STATE OF ILLINOIS
DEPARTMENT OF TRANSPORTATION

Contract # 68677

**CONCRETE PARAPET
SLIPFORMING OPTION**

SECTION
(Showing dimensions)

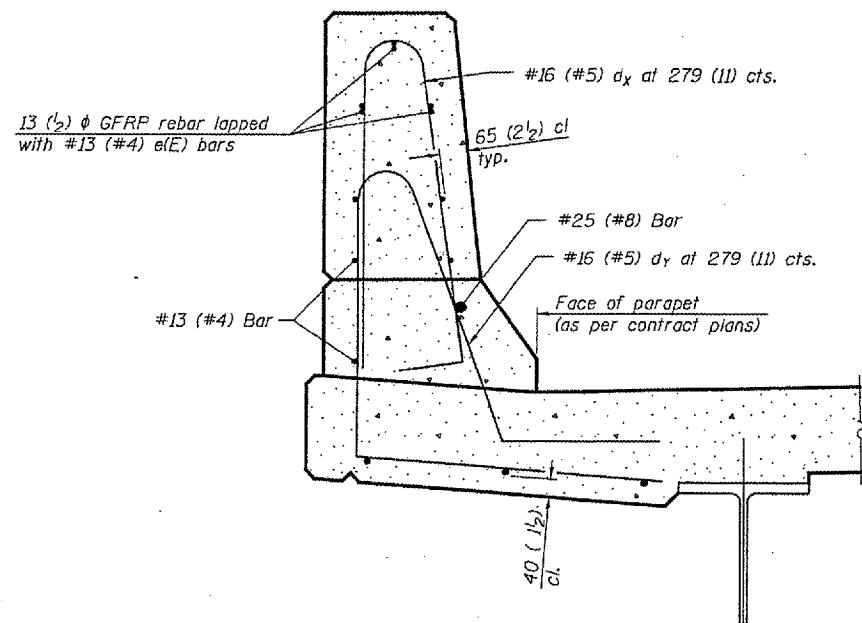
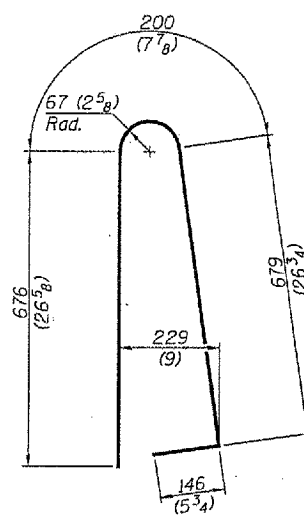
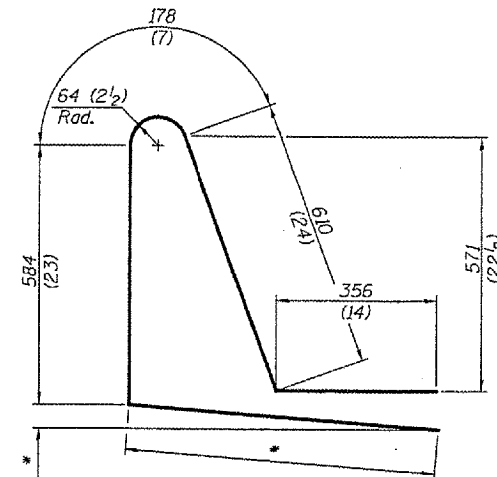
GENERAL NOTES
All dimensions shall remain the same as shown on contract plans, except dimensions A and B which are to be revised as shown to provide additional clearance. Additional concrete needed to revise dimension A and B= 0.0422 m³/m (0.165 cu. yds./ft.) of parapet. Place aluminum sheet in curb portion at and near piers. Full thickness saw cut at all other locations. Adjust/add joint locations to maintain 3 to 6 meter (10 to 20 foot) spacing.
